Work Order ID 51484

D3265-041 BASKET BASE ASSEMBLY

DRAWING NO. D3265	TITLE BASKET BASE ASSEMBLY (350)	REV. C	DART AEROSPACE LTD ENGINEERING ORDER		D.E.O. NO. D3265-C-1	SHEET NO. SHEET 1 OF 2	SCALE NTS
DRAWN <i>PH</i>	CHECKED <i>PH</i>	MFG. APPR. <i>D</i>	APPROVED <i>PH</i>		DE APPR. <i>PH</i>		
DATE 09.04.16	DATE 09.04.16	DATE 09.04.16	DATE 09.04.16		DATE 09.04.16

SHEET 3, MODIFY SECTION A-A AS SHOWN:

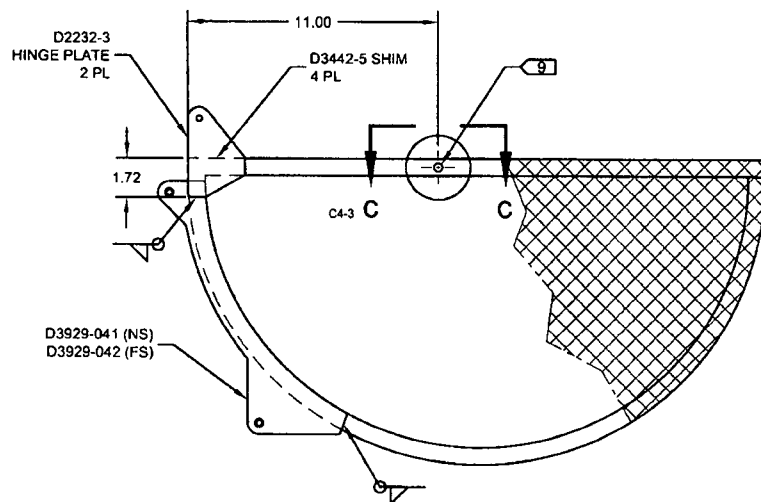
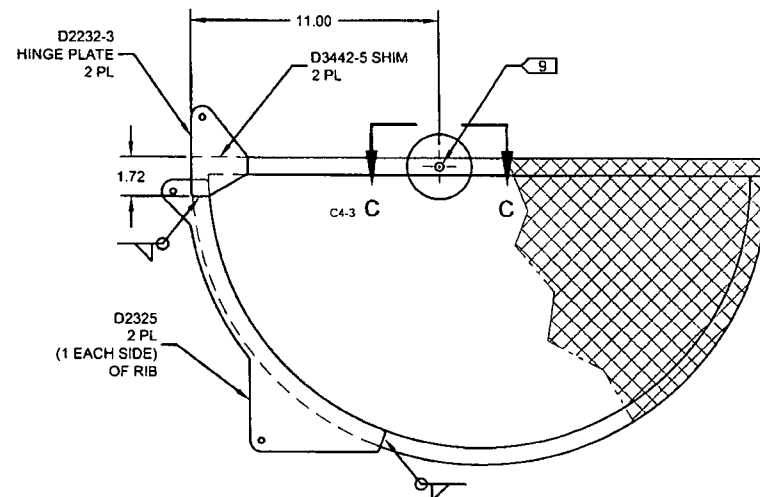
IS:

SECTION A-A A5-2
2 PL
(BOTH END RIBS)

WAS:

SECTION A-A A5-2
2 PL
(BOTH END RIBS)
